MONOLITHIC GLASS PERFORMANCE DATA

WEBSTER UNIVERSITY ISB
PROJECT NAME

RE: Stair 1 Glass For Handrail Product Data

RE: Glass handrail Samples

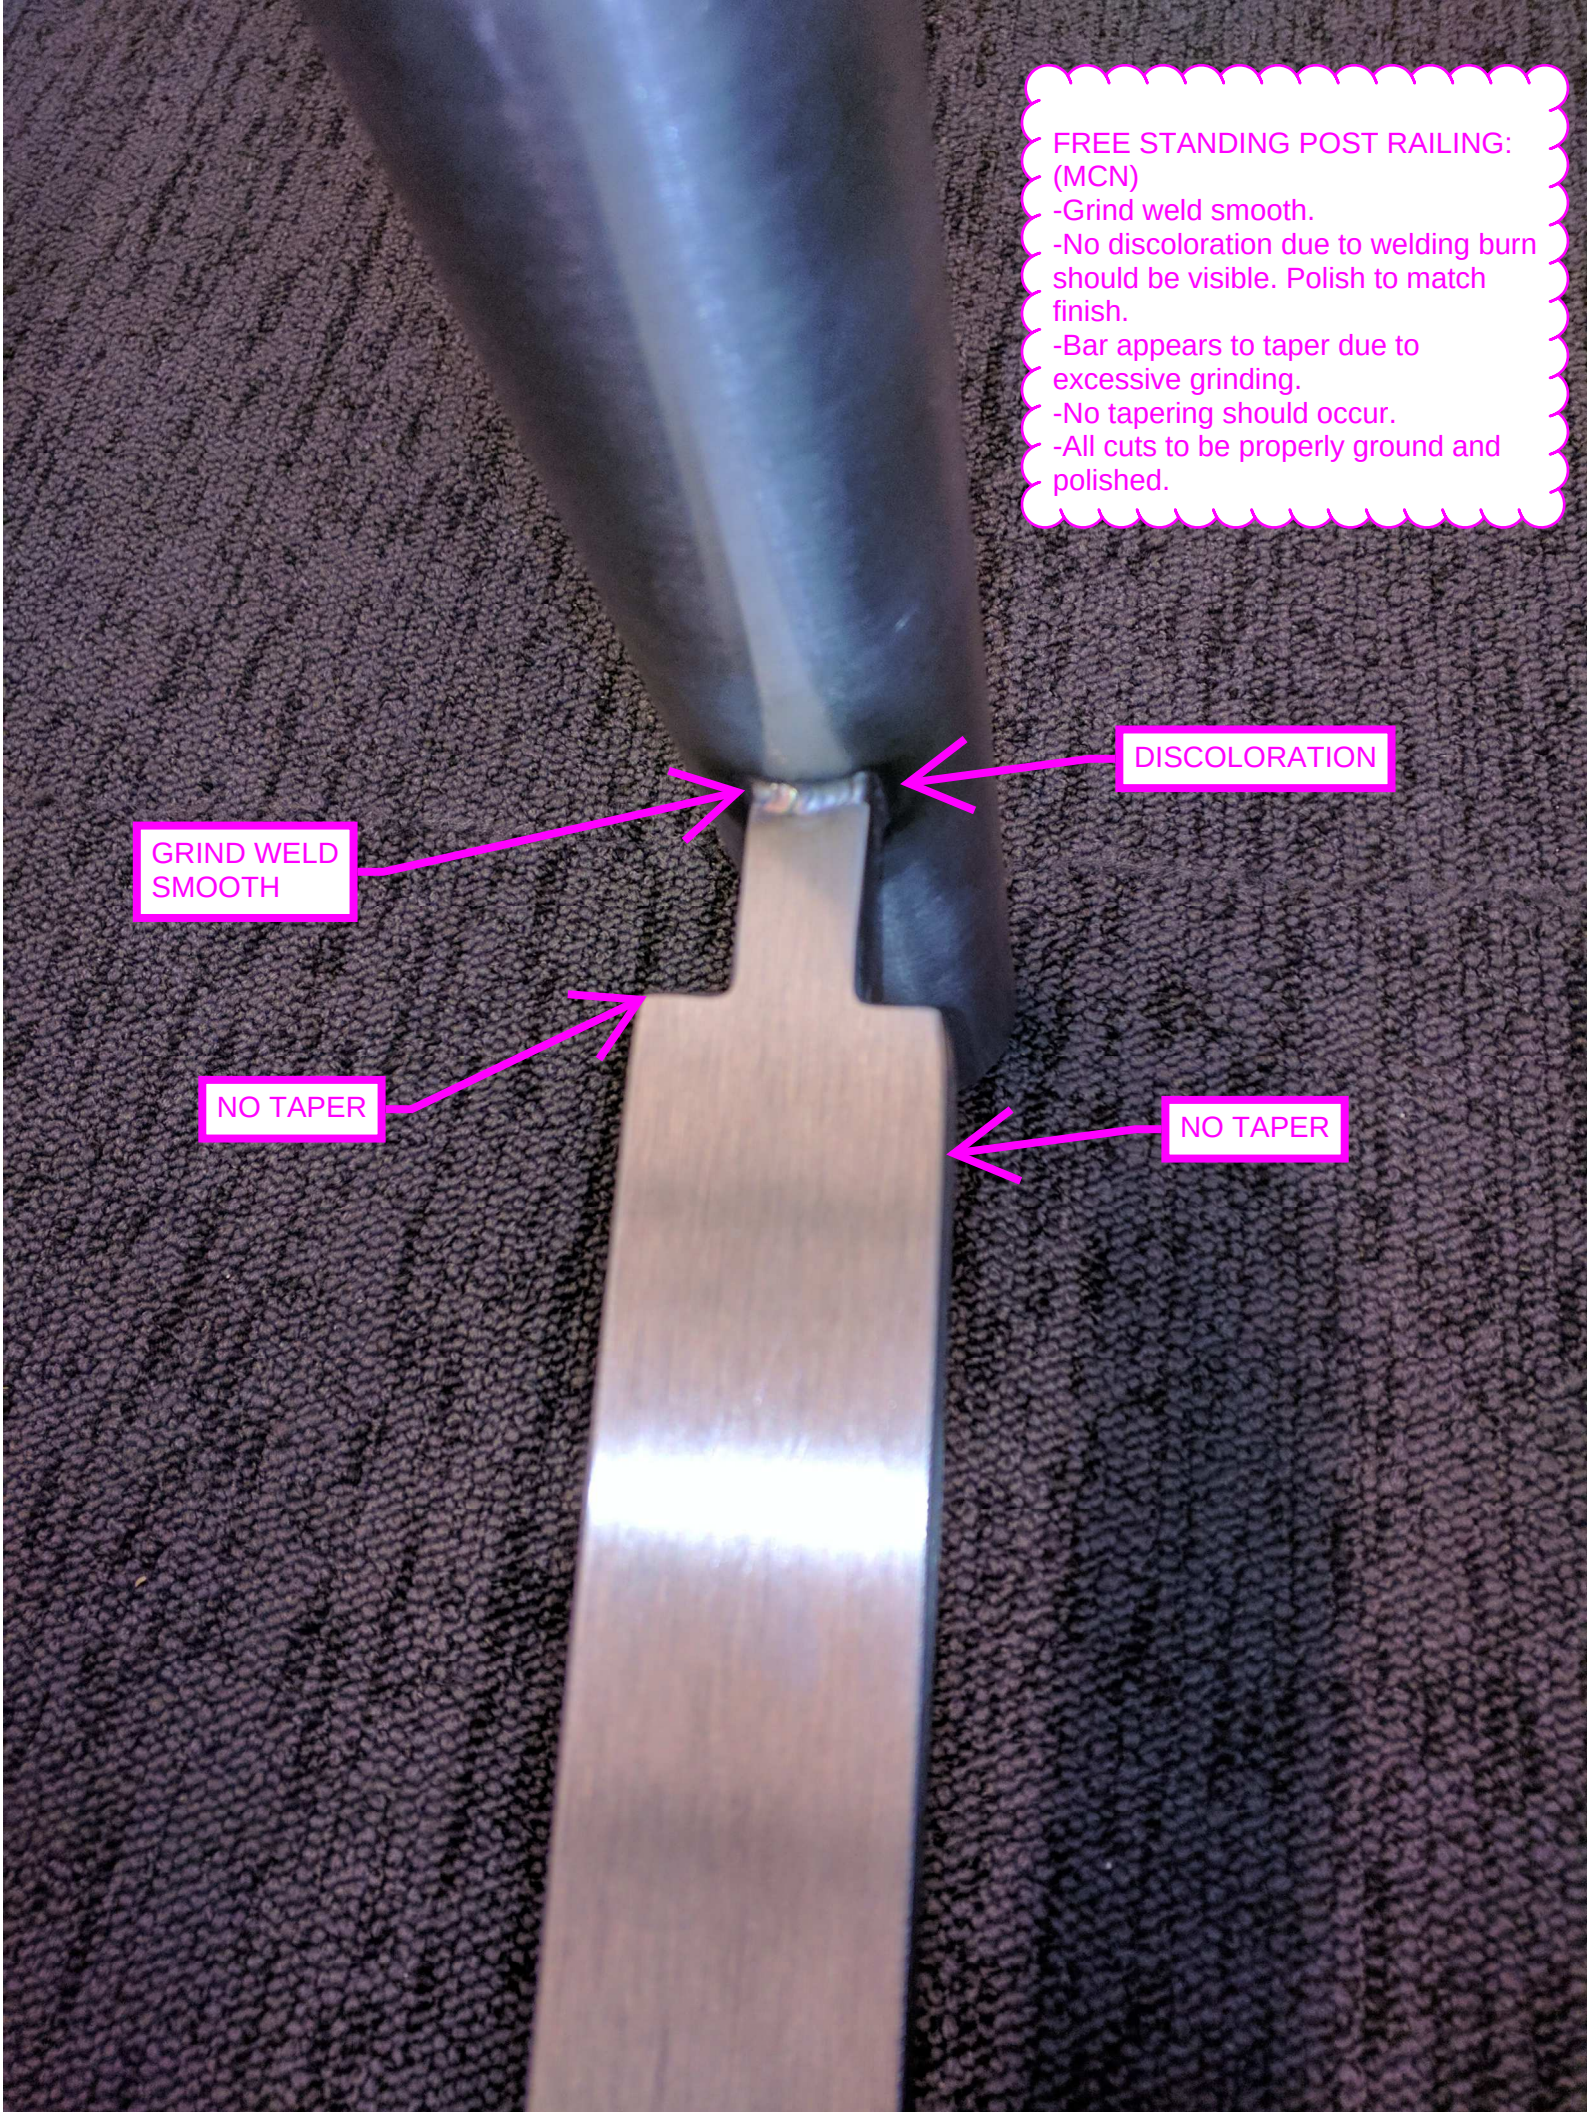
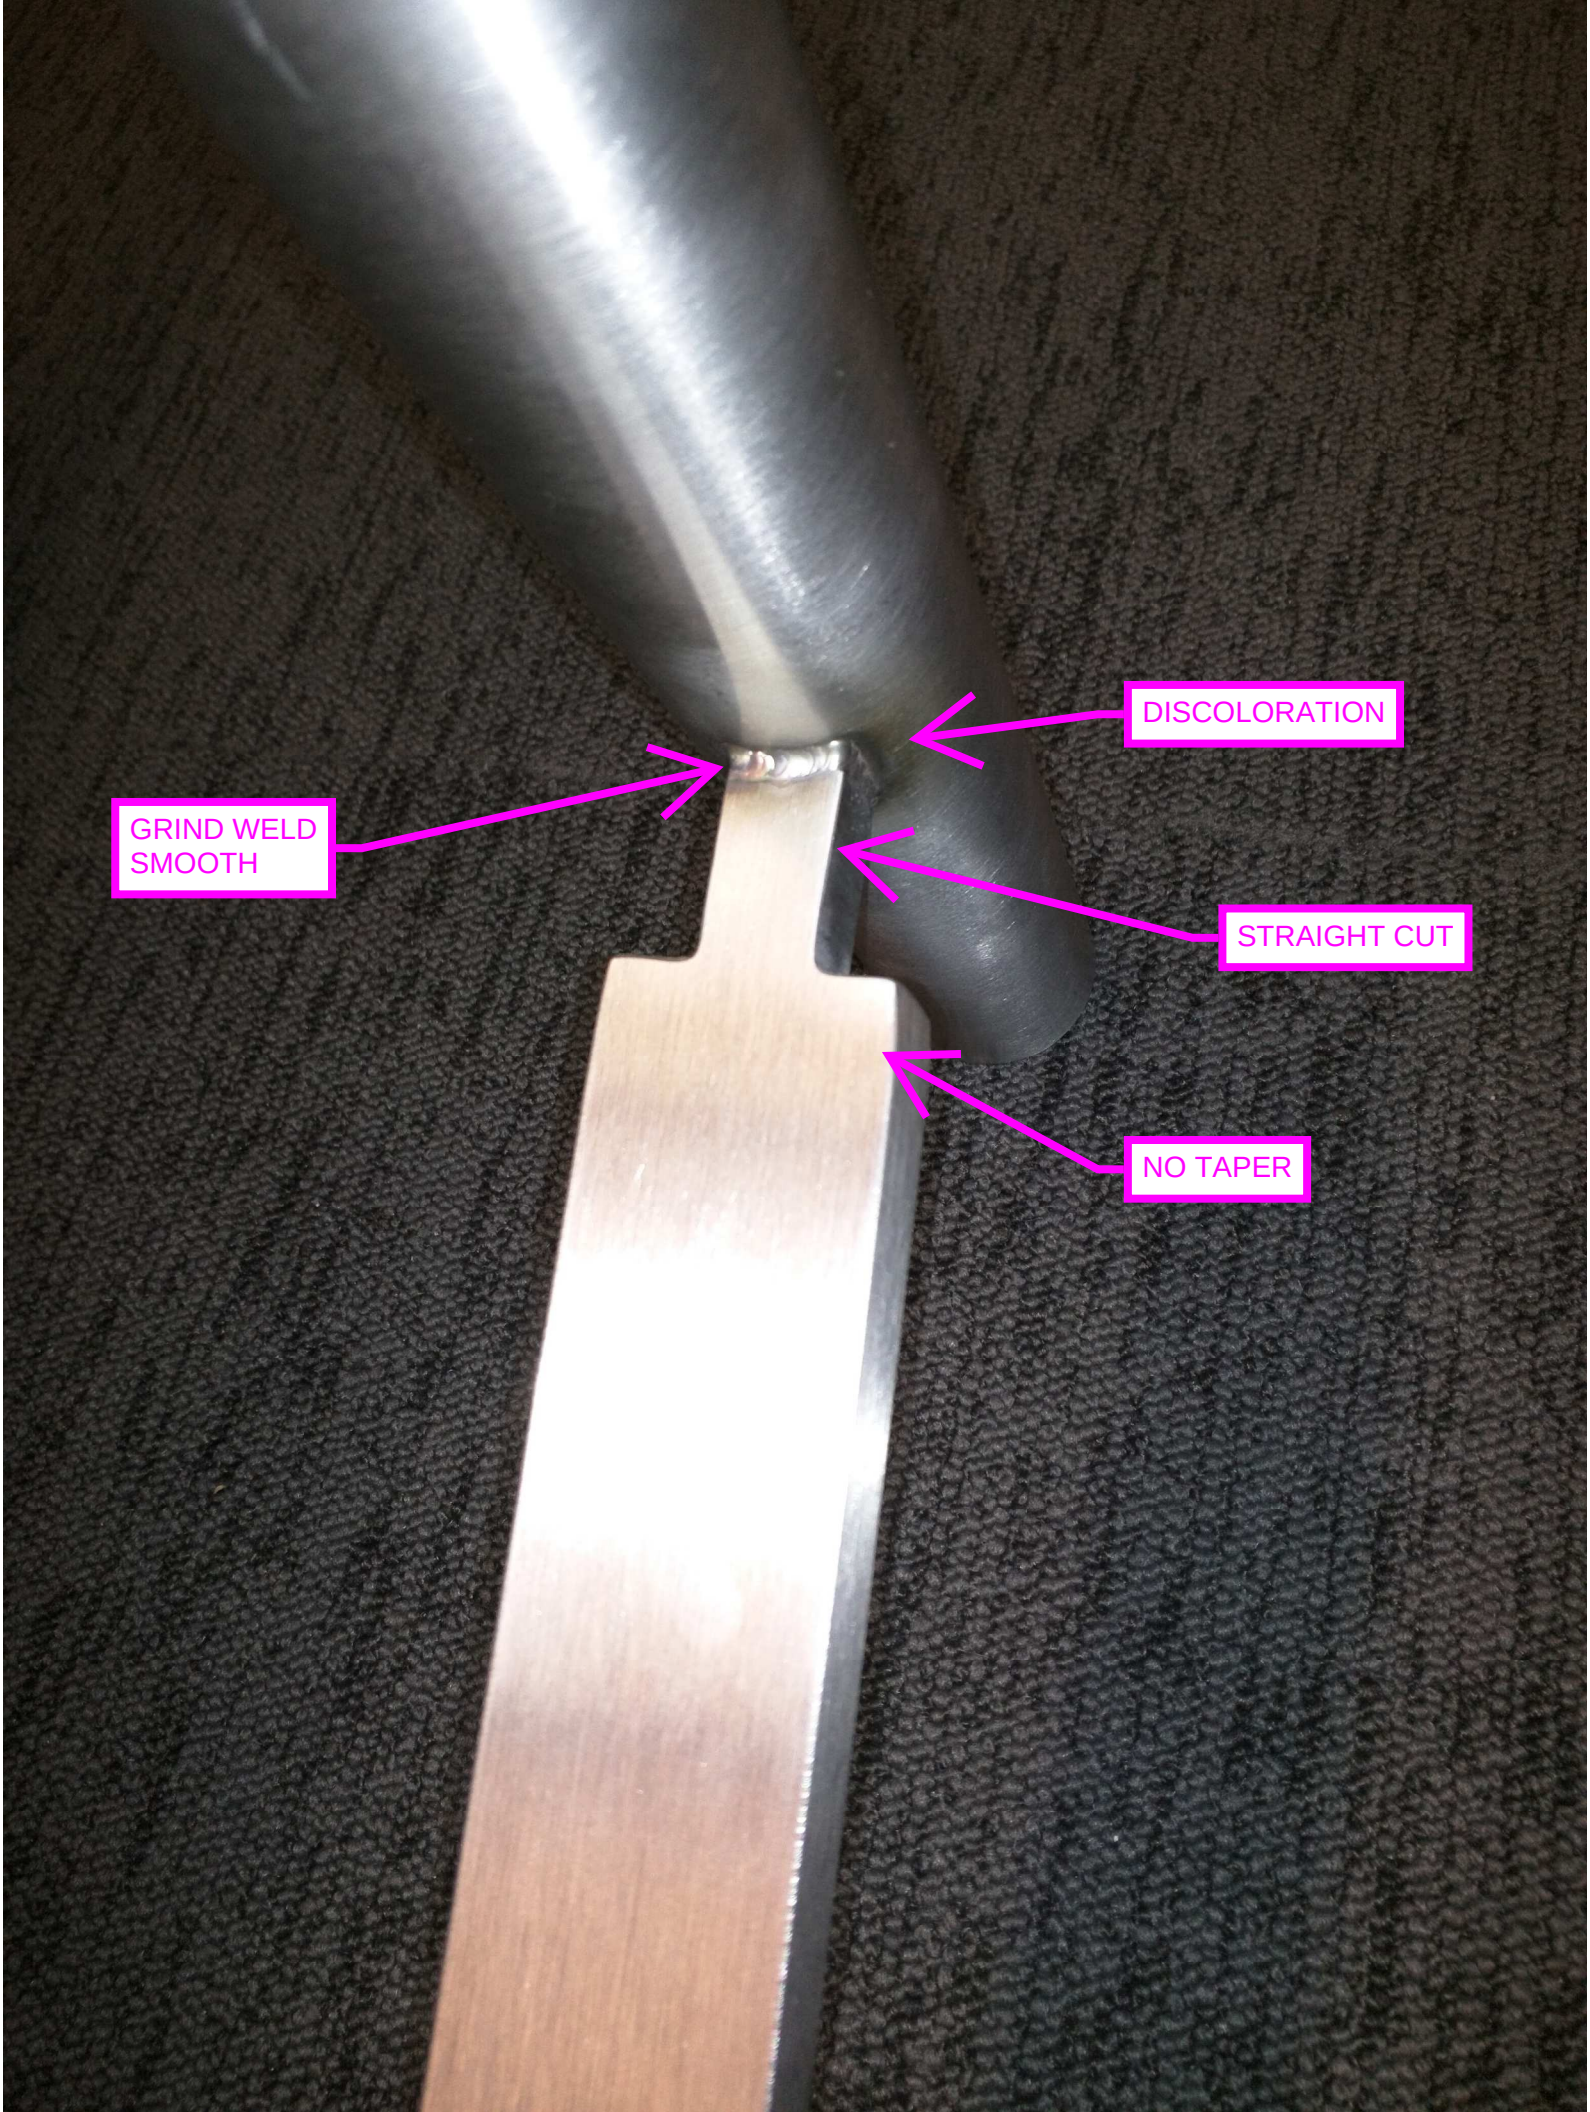
FREE STANDING POST RAILING: (MCN)
-Grind weld smooth.
-No discoloration due to welding burn should be visible. Polish to match finish.
-Bar appears to taper due to excessive grinding.
-No tapering should occur.
-All cuts to be properly ground and polished.
DISCOLORATION
GRIND WELD SMOOTH
NO TAPER
NO TAPER

DISCOLORATION
GRIND WELD SMOOTH
STRAIGHT CUT
NO TAPER

GRIND WELD SMOOTH
NO TAPER
NO TAPER
NO TAPER
FINISH CUT SURFACE PROPERLY
